# Further Statement

This Further Statement covers Proposed **Lot 49**

Amended particulars for the Proposed Lot are now shown on the attached Disclosure Plan numbered **9780 S 17 DP B\_49** as described below.

**Disclosure Plan for Proposed Lot 49 (Restricted) on SP330363**  
 Described as part of Lot 1001 (Restricted) on SP317679  
 Existing Title Reference: 51219231  
 Locality of Ripley (Ipswich City Council)

Level Datum: AHD der.  
 Origin of Levels: PSM 49894  
 RL of Origin: 62.350  
 Contour Interval: 0.25m  
 Scale @A3 1: 200  
 Dwg No. 9780 S 17 DP B\_49

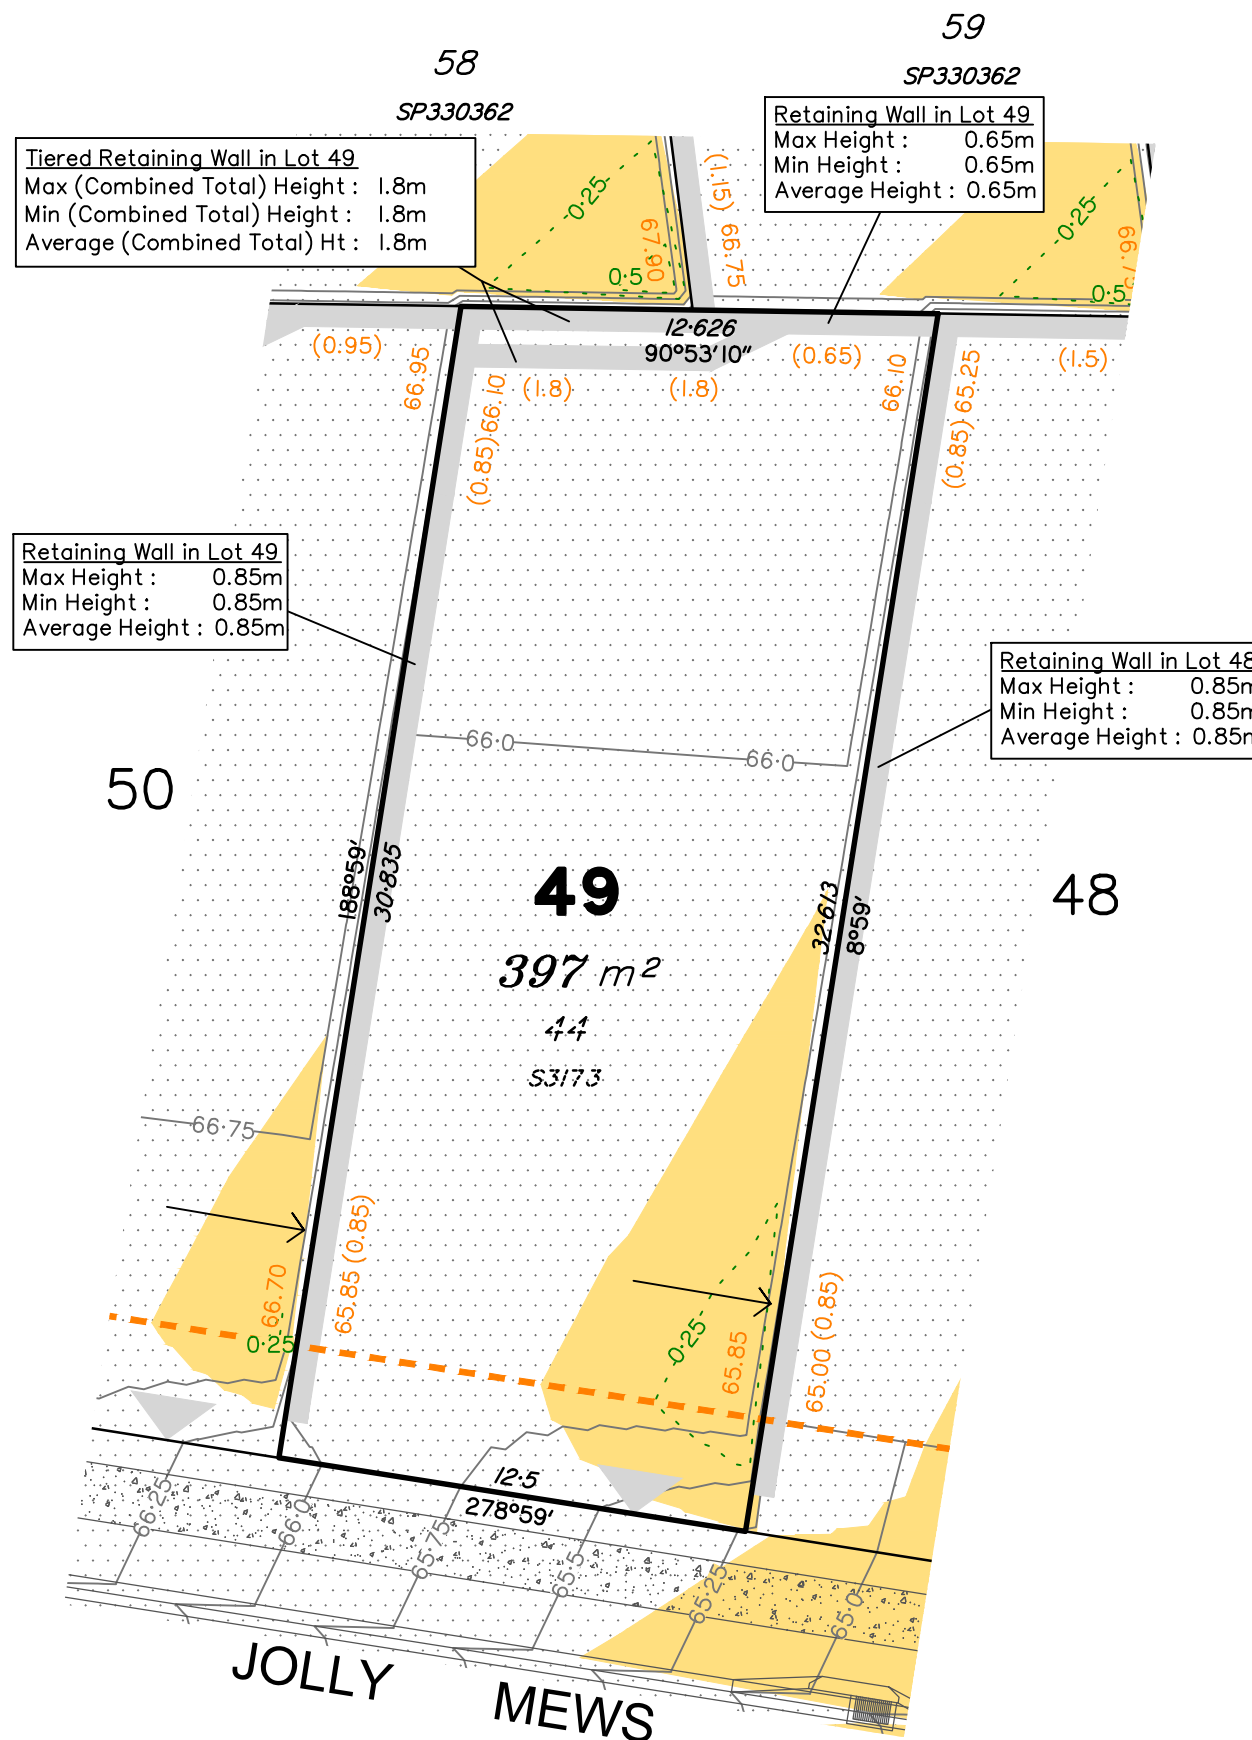
The retaining wall in the north-west corner of the lot has been changed to a two-tier retaining wall.  
The design level of adjoining Lot 59 to the north, has been reduced by 100mm, subsequently reducing the height of the single tier retaining wall in the north-east corner of Lot 49 to 0.65m.  
Adjoining Lot numbers to the north (lots 59 & 60) amended due to a typographical error.
